Kirkan Onshore Wind Farm

Additional Information

Title: Kirkan Onshore Wind Farm: Additional Information

Client: Kirkan Wind Farm Ltd

TITLE: Figure 1.1: Proposed development layout

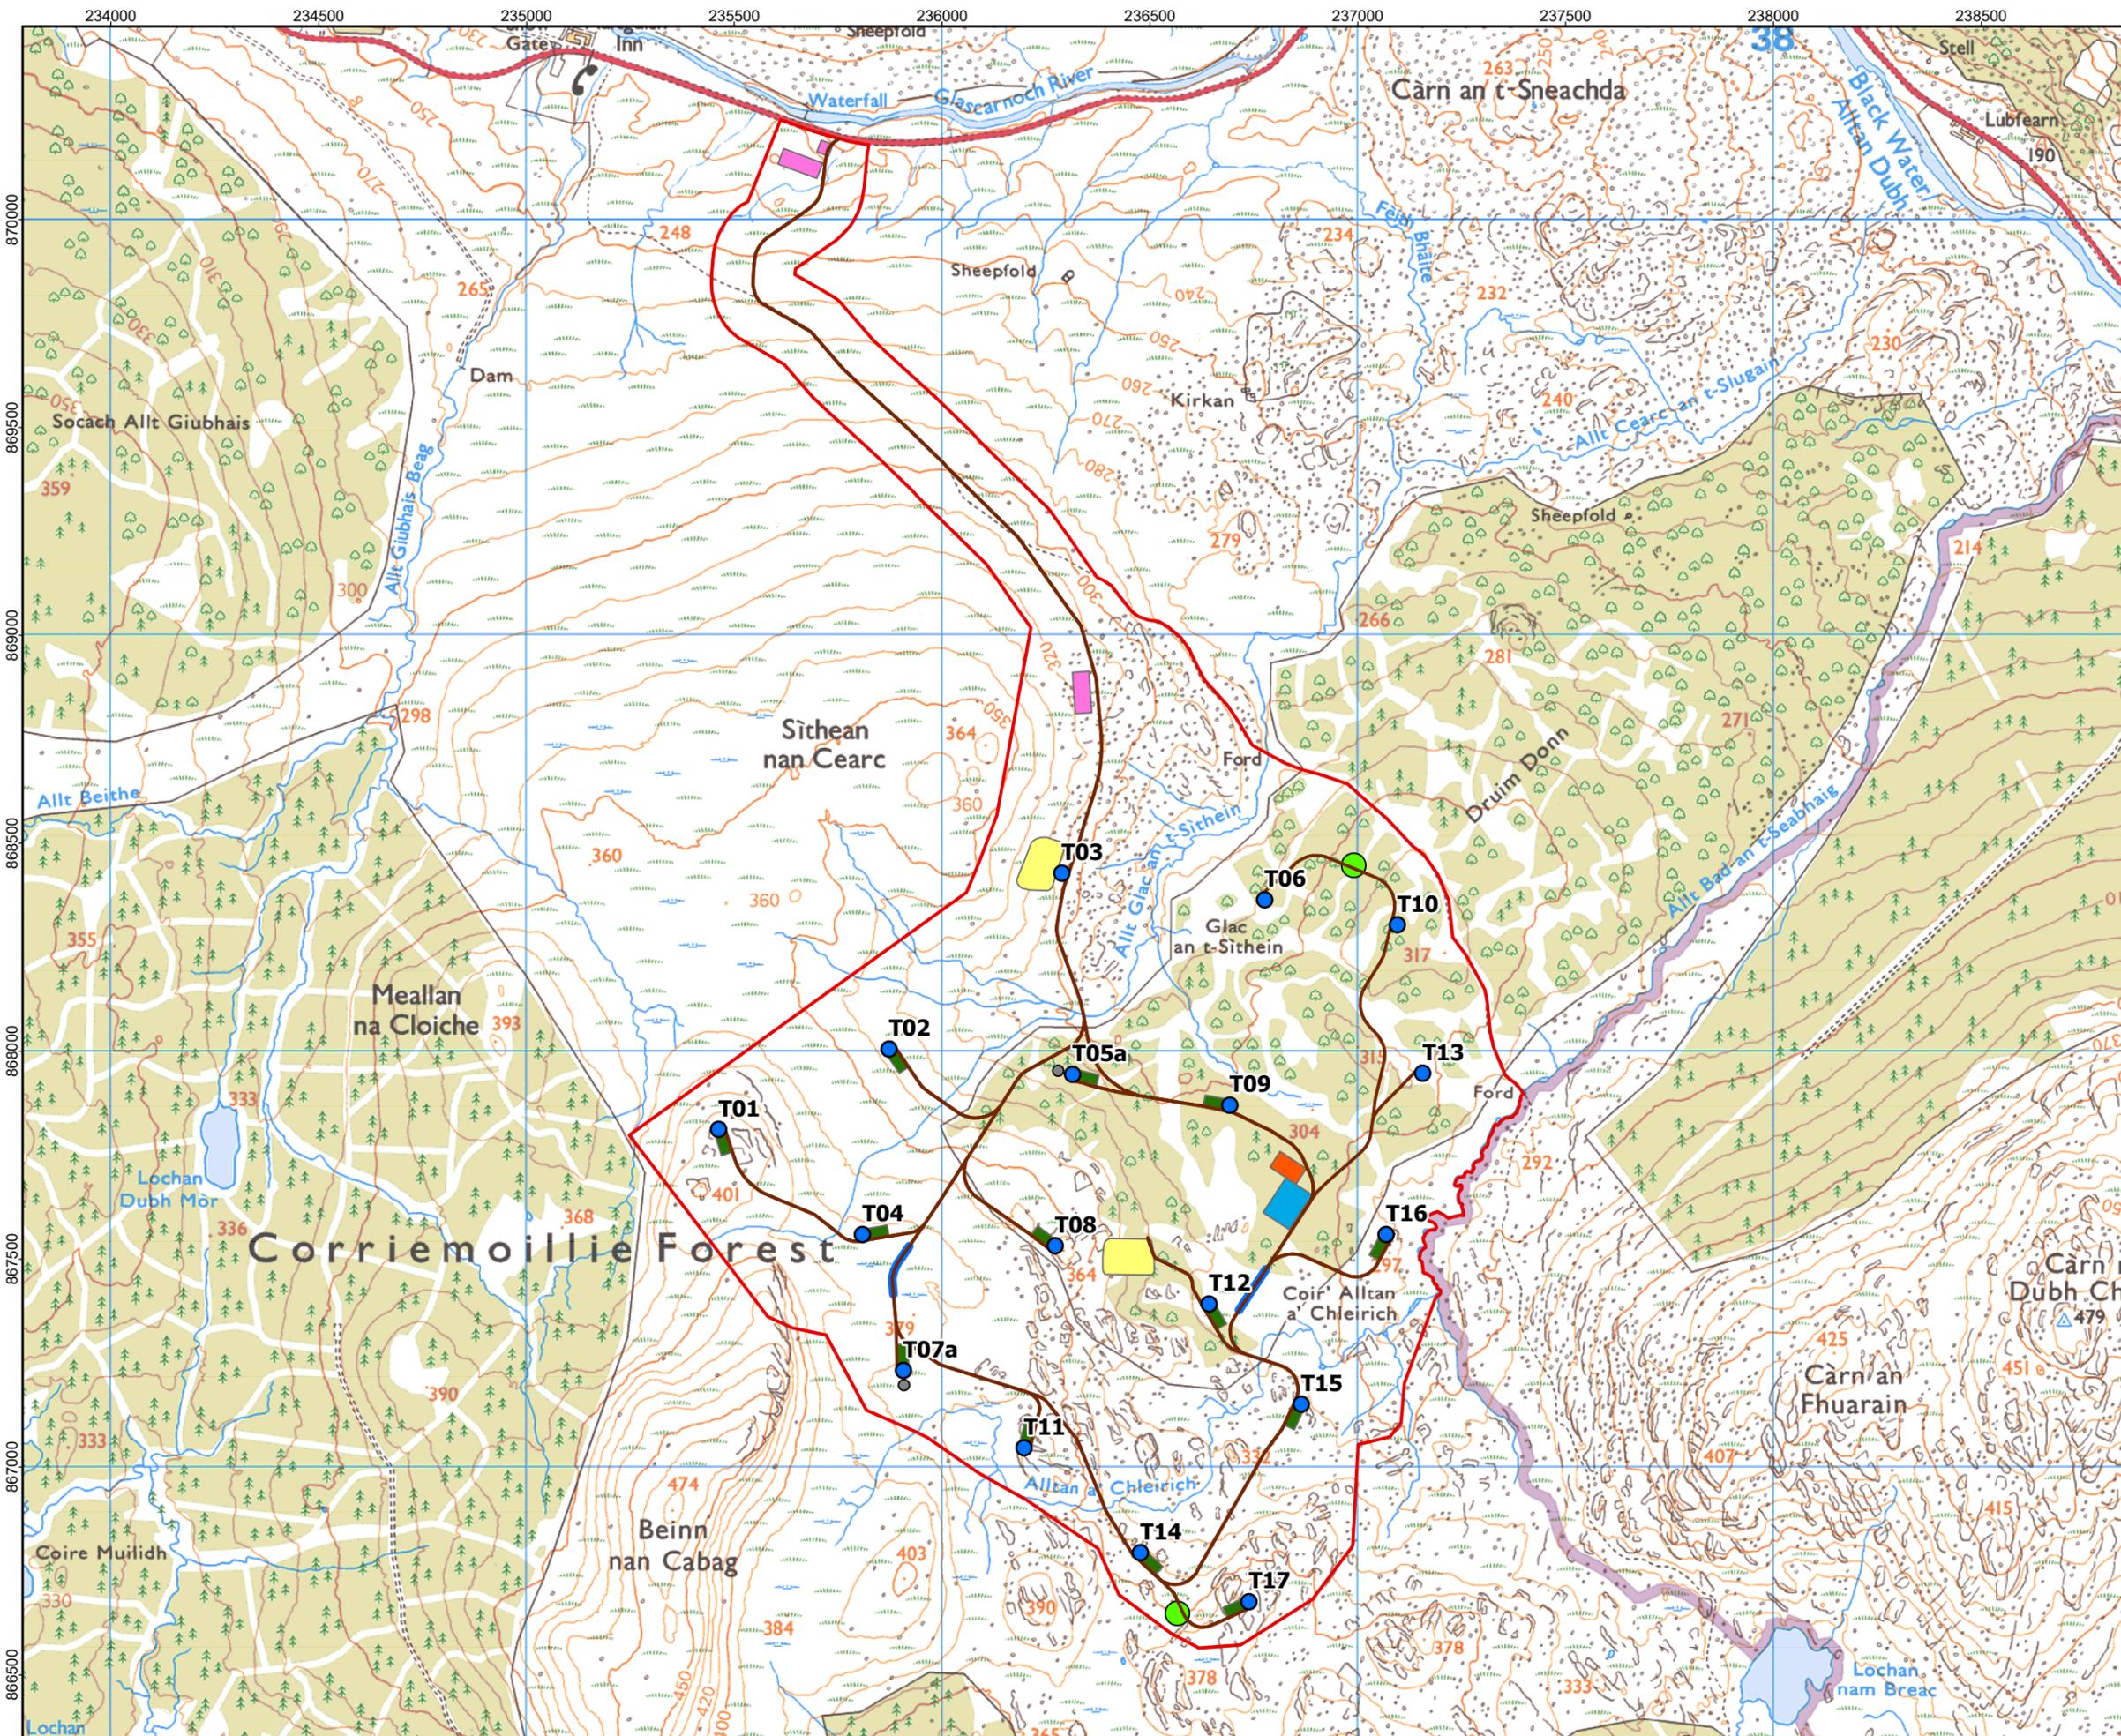
- 1.3 The AI contains includes one change to the proposed development design. Figure 1.1 (Appendix 1) shows proposed changes to the locations and connecting track orientations for Turbines 5 and 7 in response to an objection maintained by SEPA, following the SEI.
- 1.4 In summary:
- Turbine 5 has moved 35.9 m east-southeast from its former location
 - Turbine 7 has moved 35.3 m north from its former location.
- 1.5 Further clarification on this matter is provided in Chapter 2: Hydrology and Peat.
- 1.6 The AI report also includes a summary assessment from the other environmental specialists involved in the EIA on the implications of the design revision for their

- 2.3 In response to SEPA's concerns, both turbines 5 and 7 have been relocated by a small amount and are now located in areas with considerably less peat than at their previous positions (See Figure 1.1). Small consequential adjustments to the track layout have been required to accommodate these changes.
- 2.4 An overall reduction in anticipated peat excavation of 15% from the original layout, and 9.4% from the SEI layout, have been achieved by these small adjustments, the details of which are provided below.

Figure 3.1 - Transportation Routes, Recreational Routes and Summits within 10km

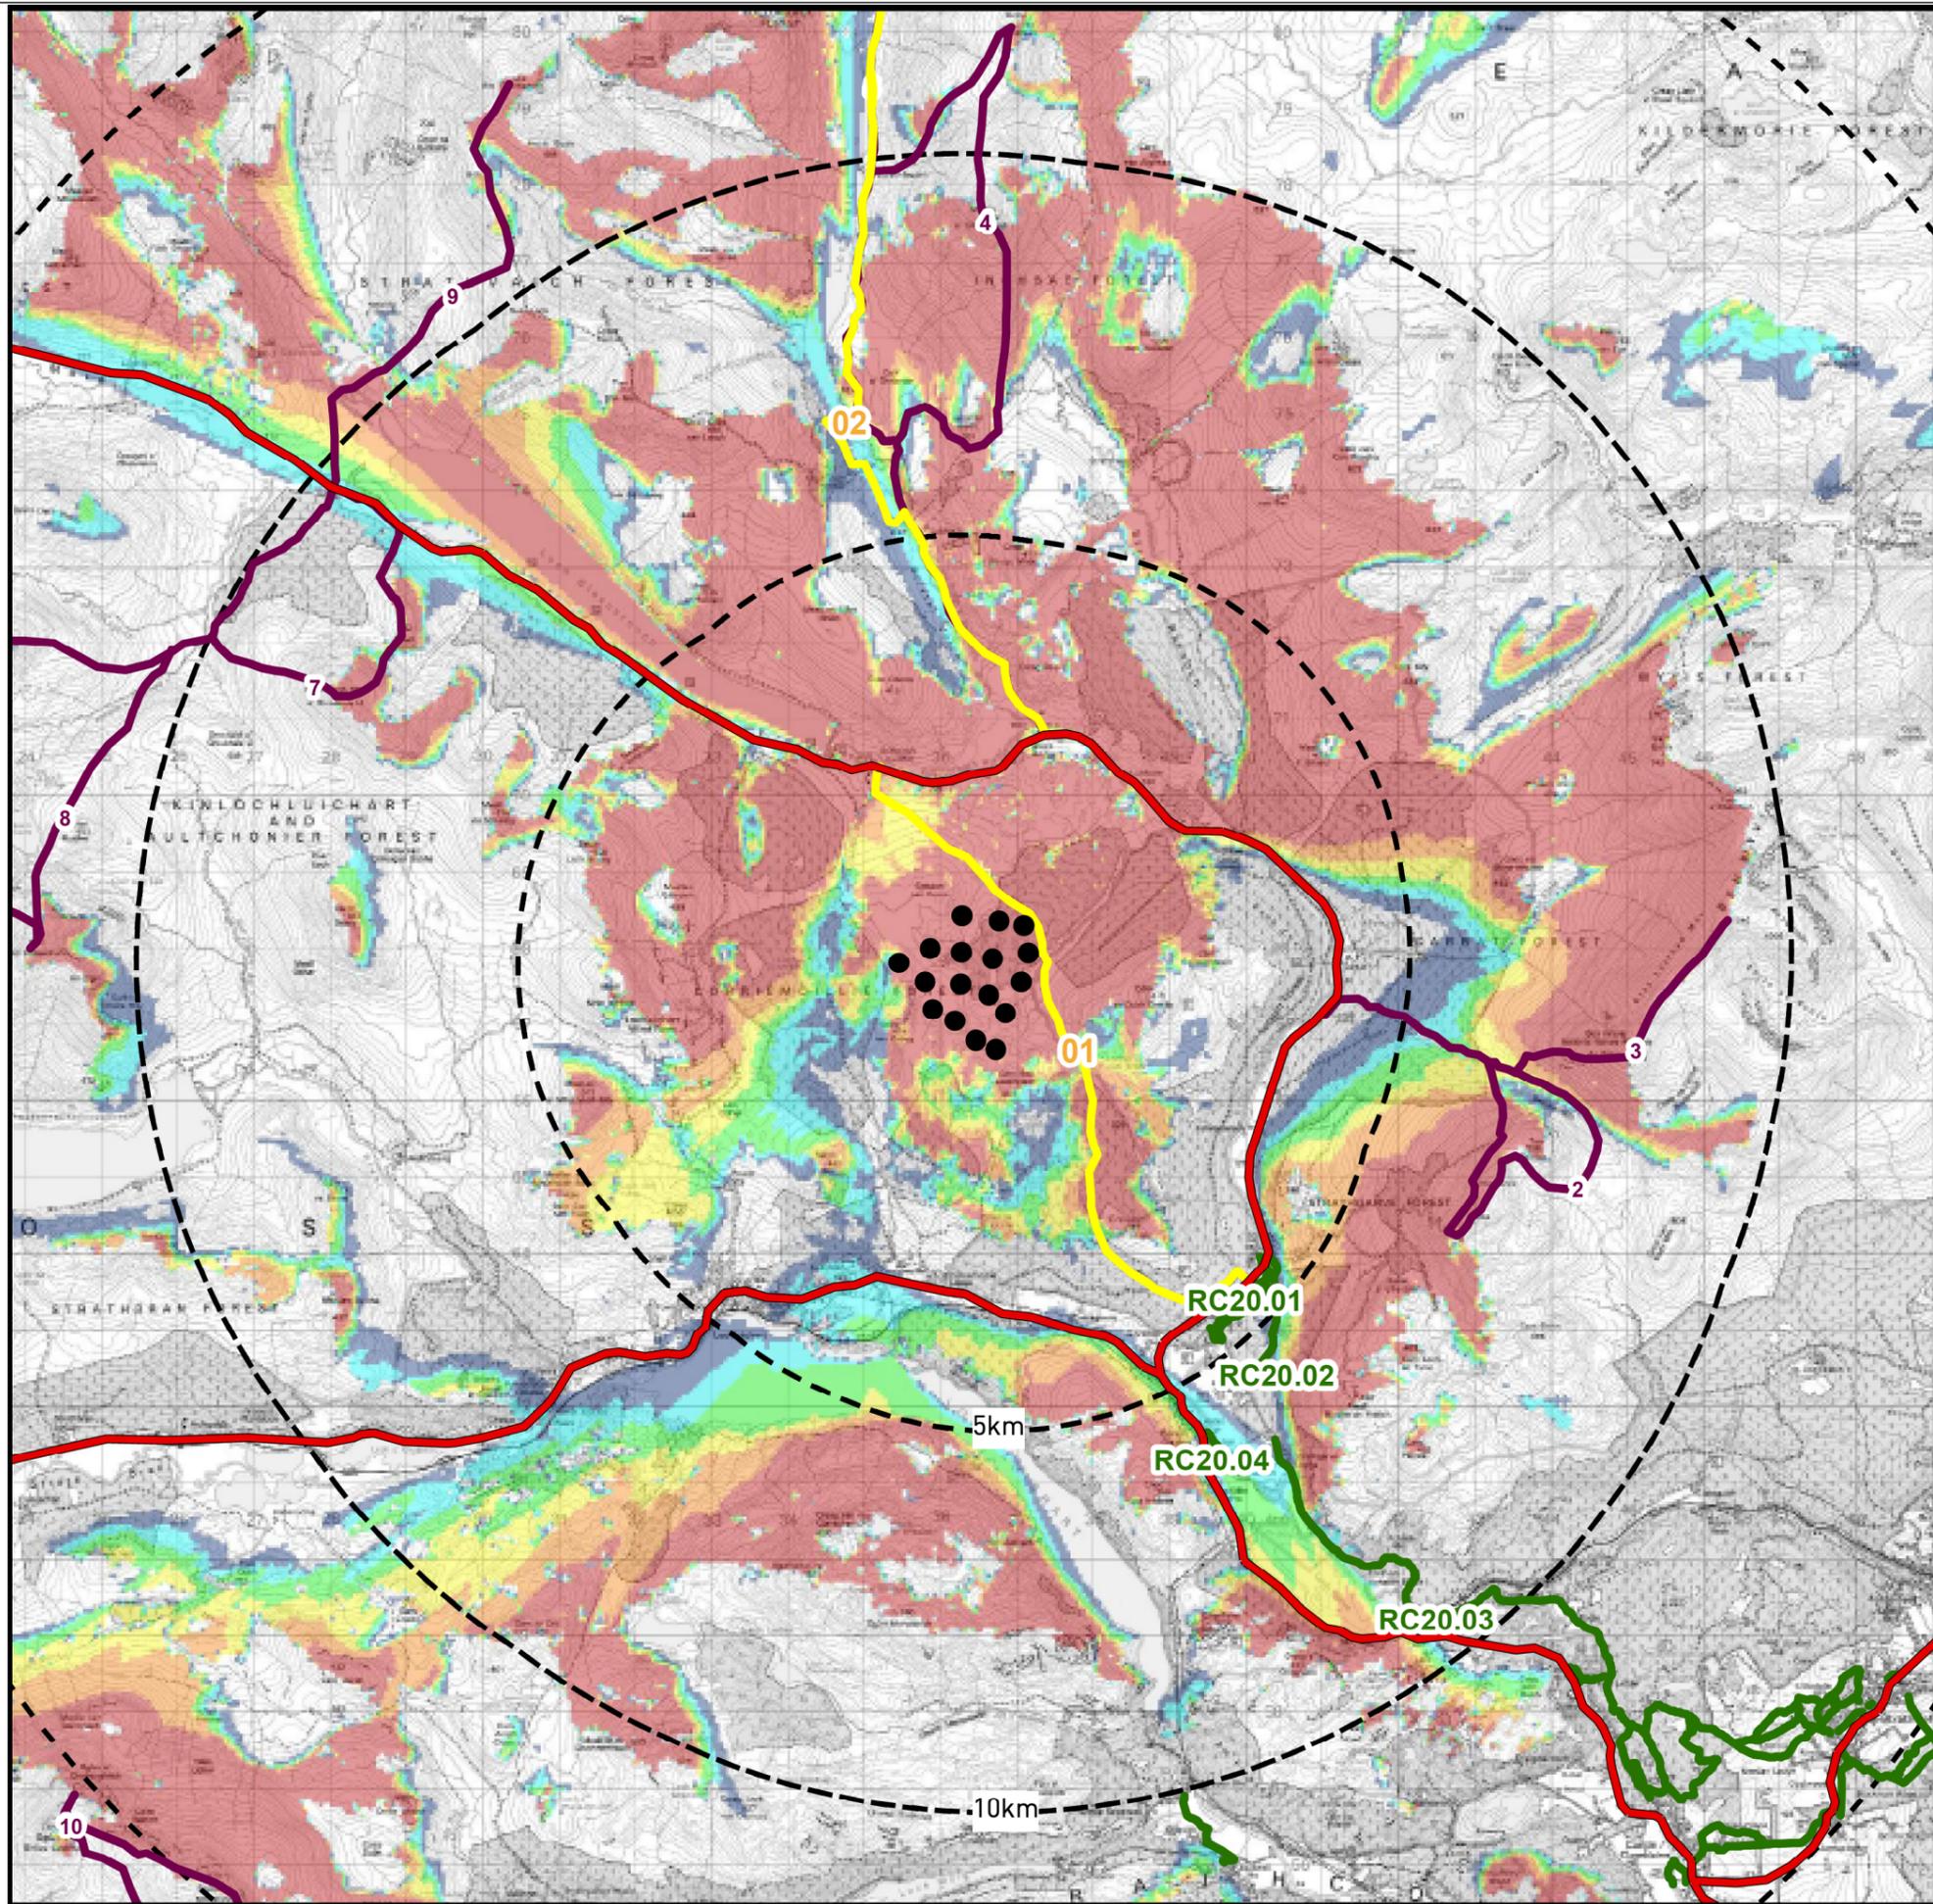
- 3.3 ScotWays’ response also noted that some of the information in relation to Figure 4.4 Transportation Routes, Recreational Routes and Summits in the EIA report Volume 3 Graphics was incomplete, and requested confirmation of the length of HR46 that would be upgraded.

- 3.7 For reasons of completion, an updated version of Figure 4.4 Transportation Routes, Recreational Routes and Summits is provided to accompany this report, as Figure 3.1 (Appendix 1).
